Easton Staff Development Review MEETING AGENDA

- a. **Application Number:** 2023-12
Location: Elliott Road
Tax Map 109, Parcel 2849, Lot 4
Applicant: DMS & Associates, LLC
Request: Sketch Site Plan and Stormwater Management review of a proposed climate-controlled self storage facility.

06/2023 Comment Response
From DMS + Assoc.
+
Fink Whitten
on behalf of
Friel Storage, LLC.

Sketch SITE PLAN REVIEW – Elliott Road, Lot 4 – Climate Controlled Self Storage

DATE MAY '22	SCALE 1" = 20'
JOB No. 2022009	DRAWN BY WJM
FOLDER Ref. 109-2022009	DESIGNED BY BD
SHEET No. - C-4	
CADD FILE - 22009C04

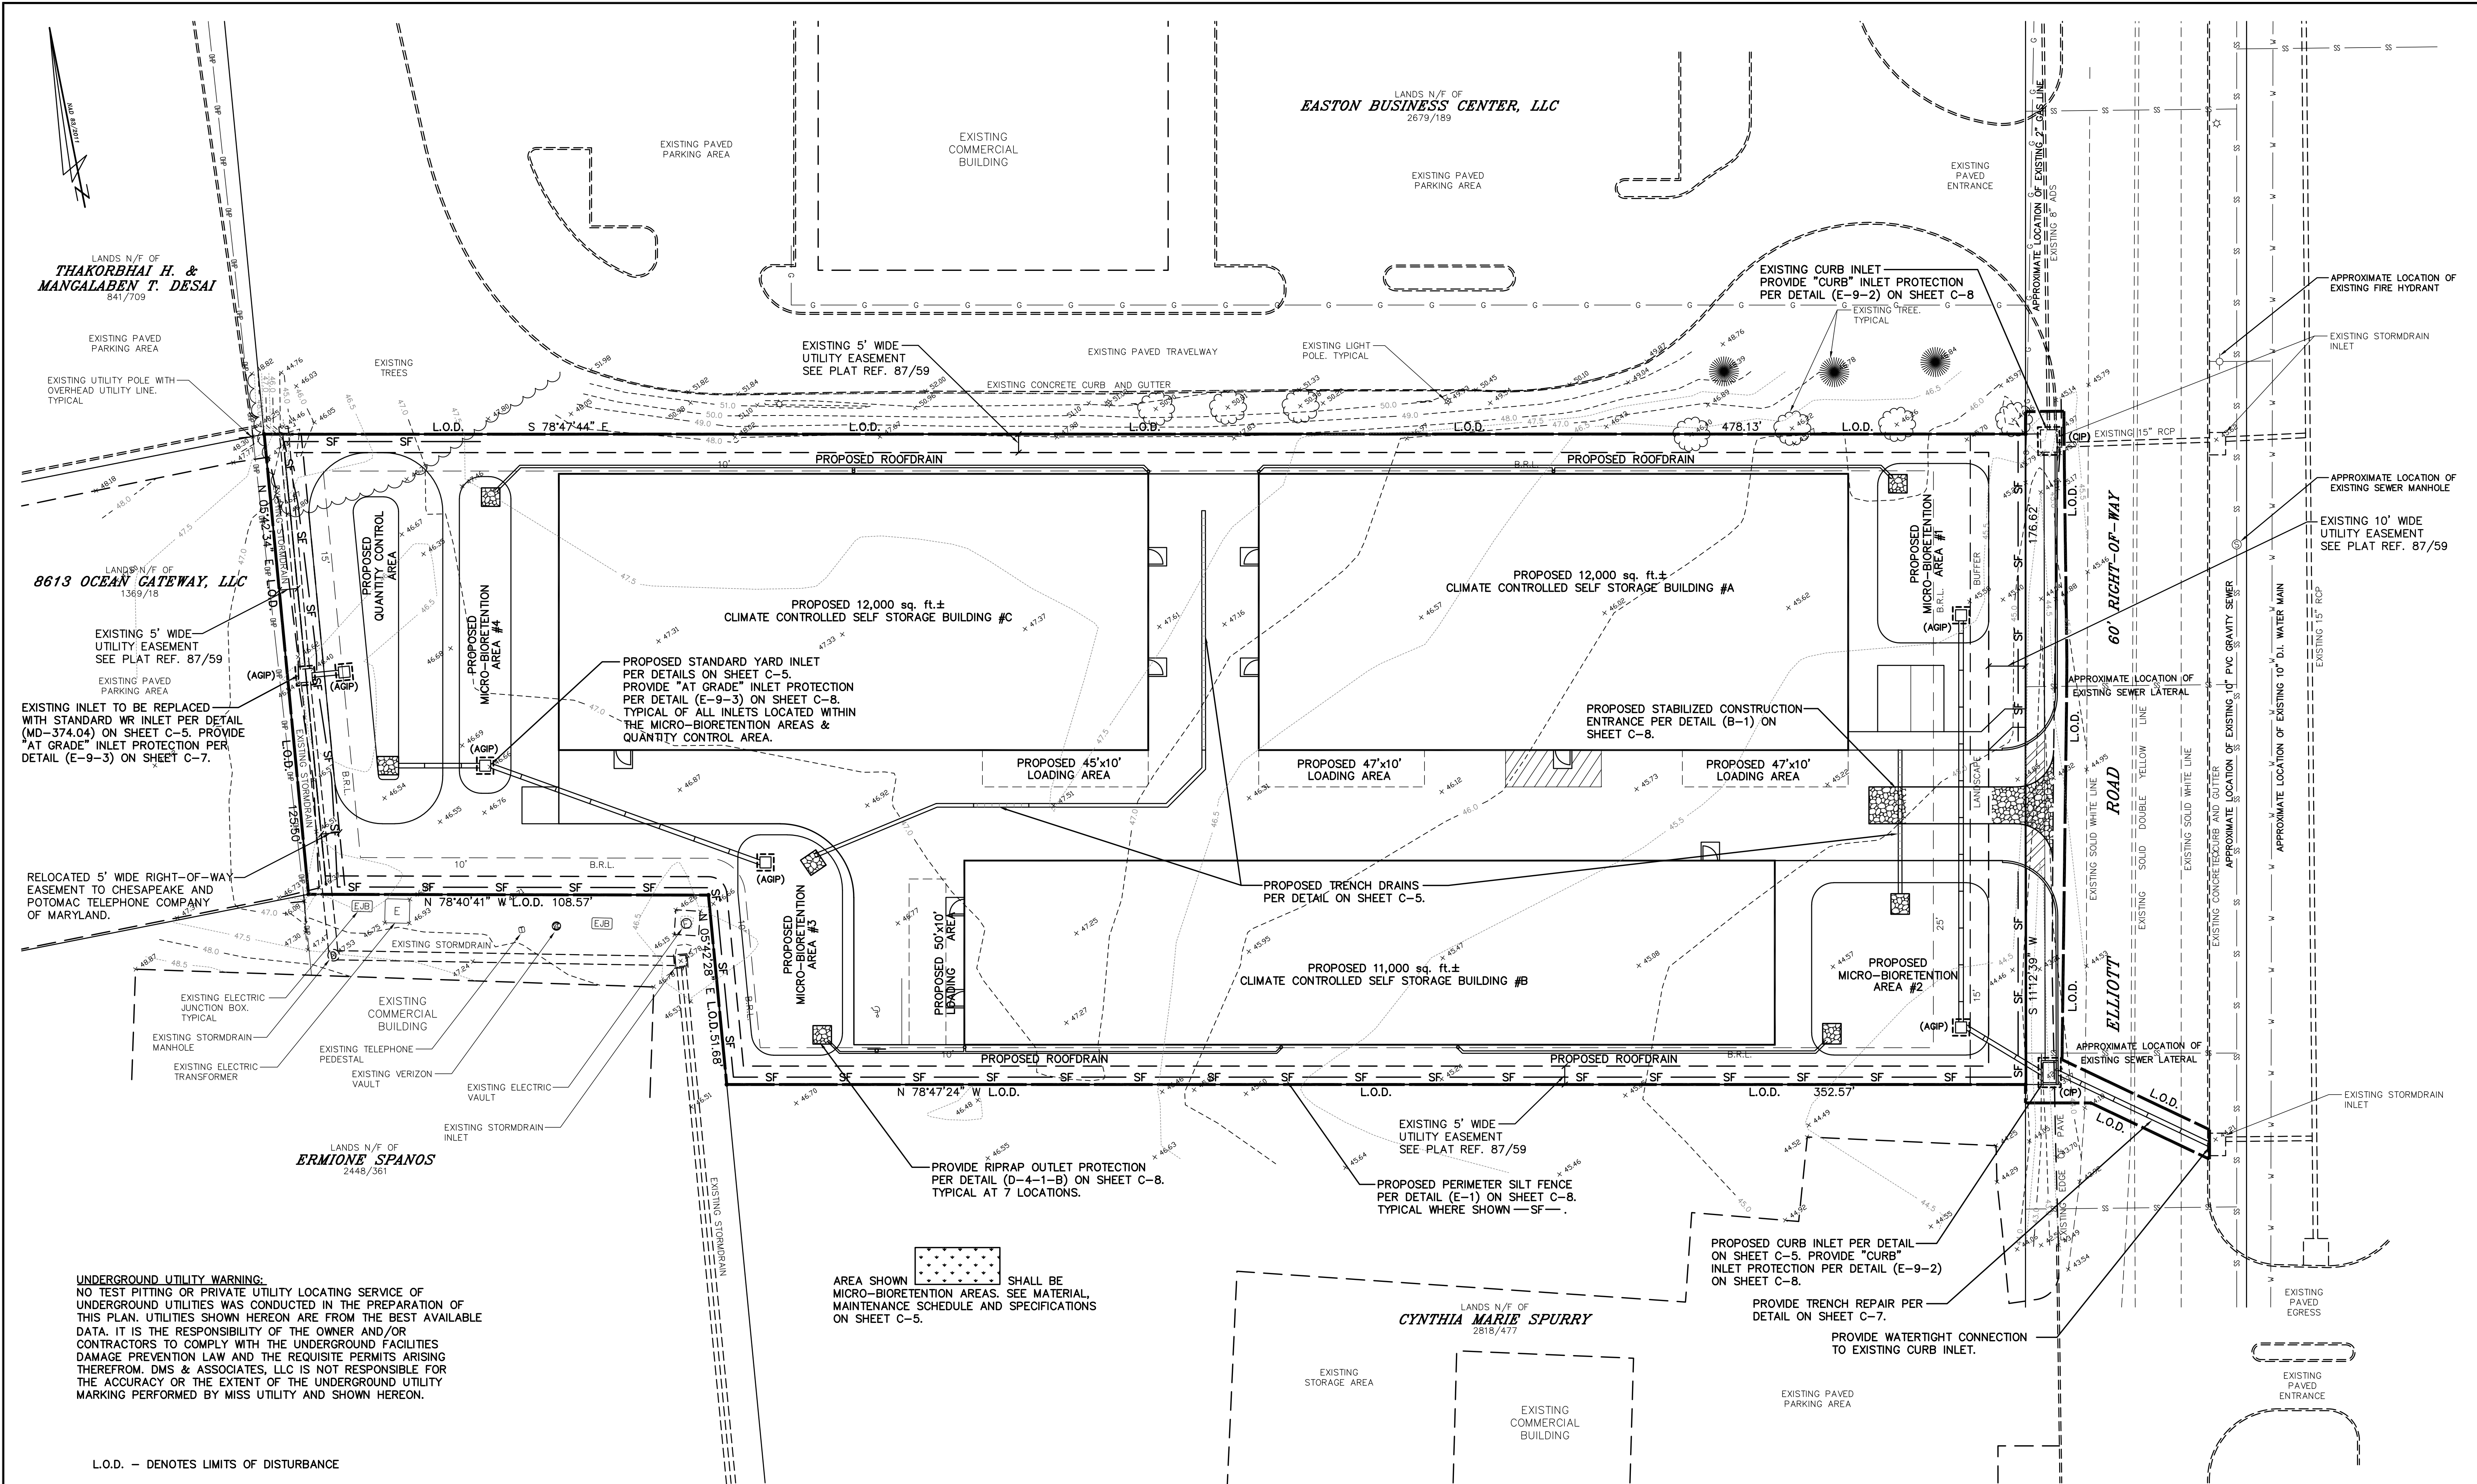
3. **SHEET C-3** - It appears the "PROPOSED **QUALITY** CONTROL AREA" label should be labeled "PROPOSED **QUANTITY** CONTROL AREA". *label corrected*
4. **SHEET C-4** - Provide a doghouse structure at the tie in to the existing stormdrain on the west edge of the property. *SD configuration revised*
5. **SHEET C-5 - INSPECTION REQUIREMENTS DURING CONSTRUCTION** - Revise "STORMWATER INSPECTOR" to "ENGINEERING DEPARTMENT" in the first sentence. We have recently changed our policy to have contractors contact the office instead of the inspectors directly for better recordkeeping. *due to available invert depth.*

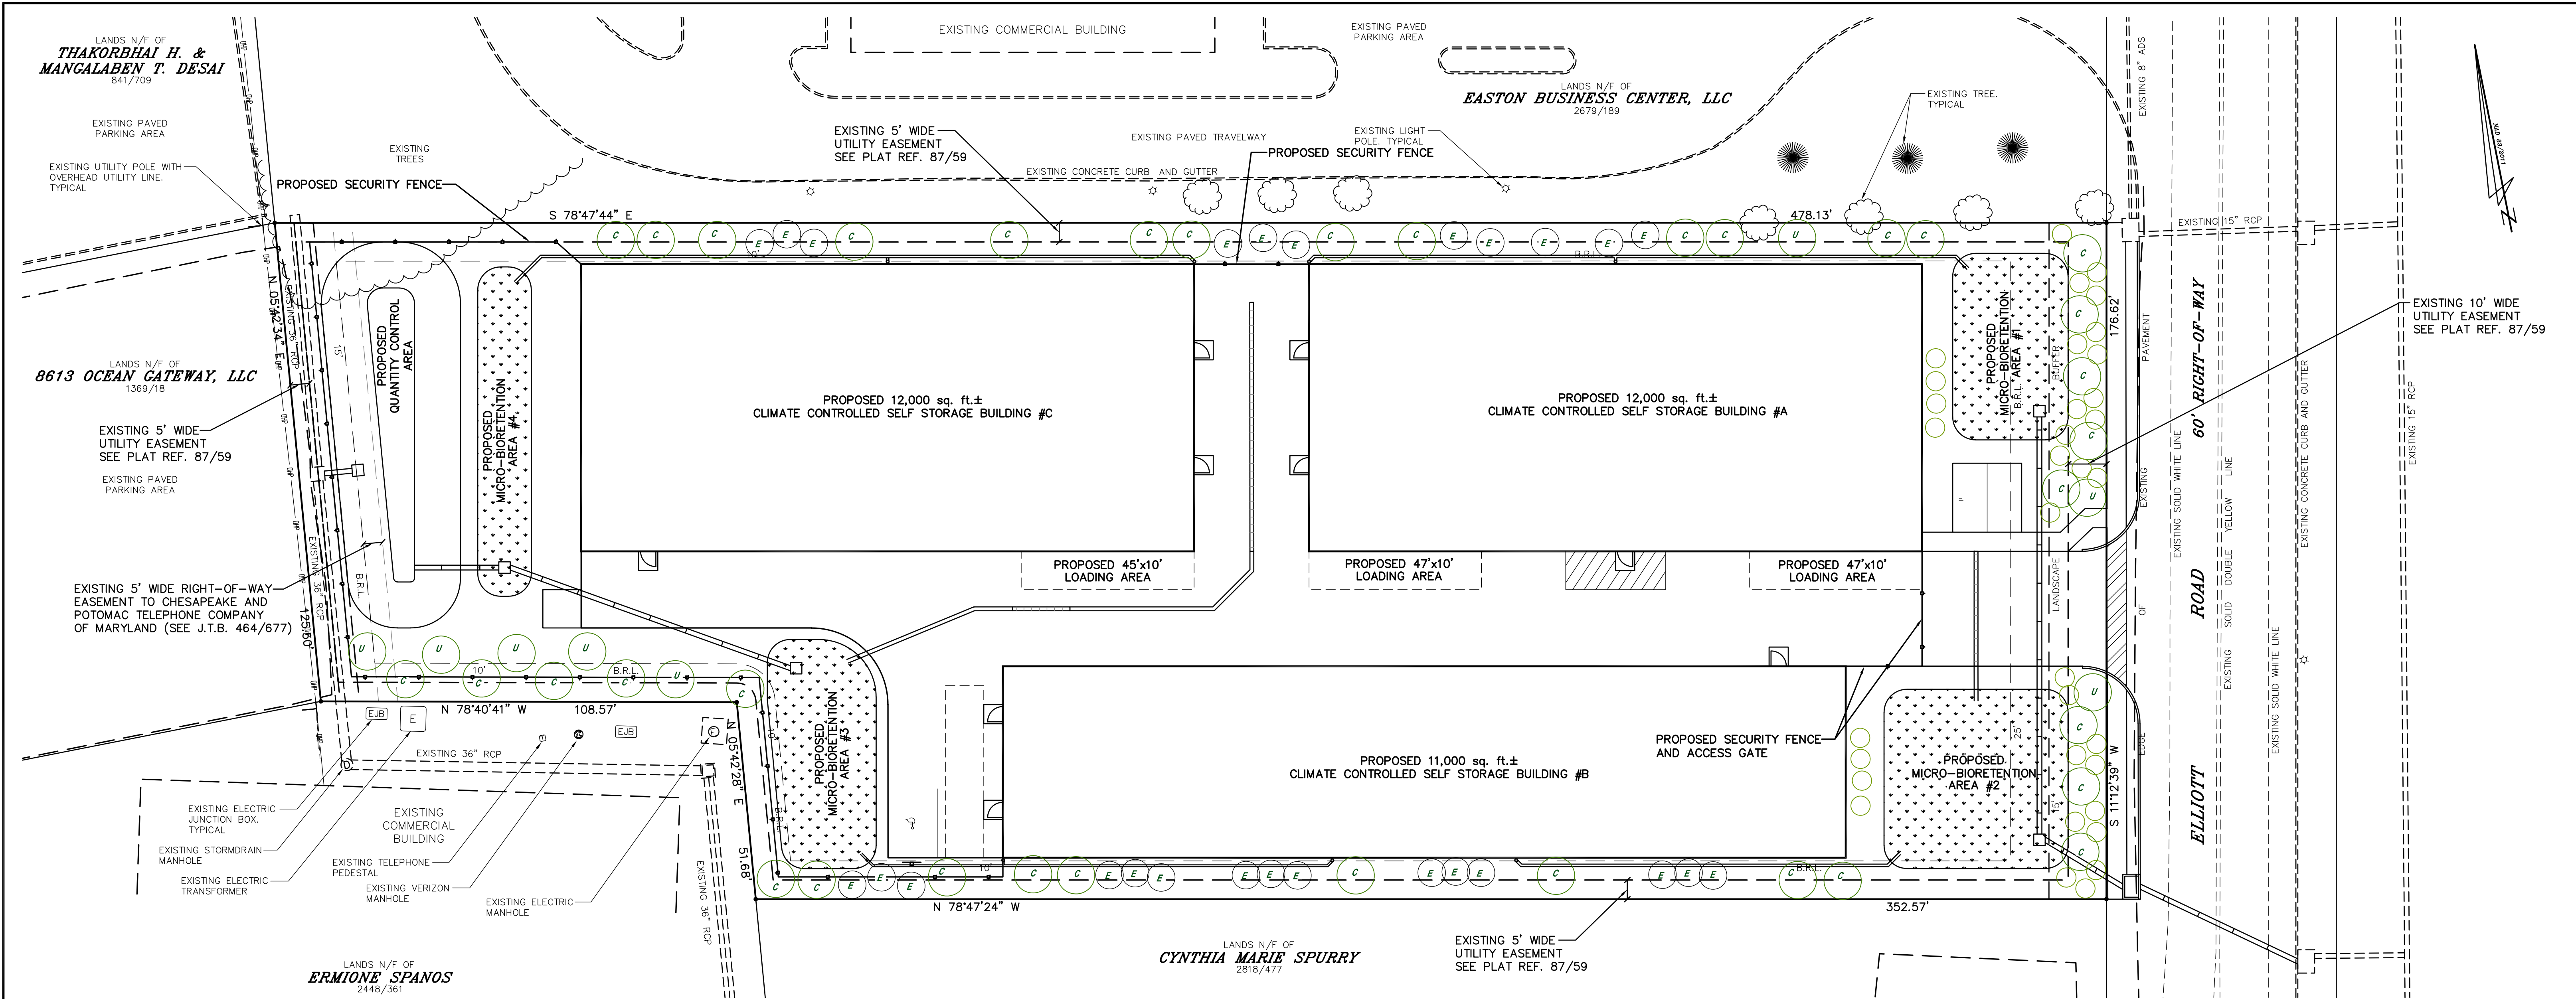
5. Label the Bufferyard on the Landscape Plan and provide calculations. Remove the Bufferyard Easement line out of the proposed road and Micro-Bioretenention Area #2. The Micro-Bioretenention Area #2 will need to be adjusted to maintain the 15' wide Bufferyard. *28-1014.7.D.2 allows for SWM to be in the landsc. buffer. 15' Landscape Buffer is labeled on L-1.*

6. Verify and label on the Site Sketch Plan that all proposed landscape material will be native plant species. Please see the "Talbot County Buffer Management Plan Guideline & Plant List" for reference. In addition, please supplement with "U.S. Fish & Wildlife Service, Native Plants for Wildlife Habitat and Conservation Landscaping – Chesapeake Bay Watershed." *The legend on L-1 has native with all plantings.*
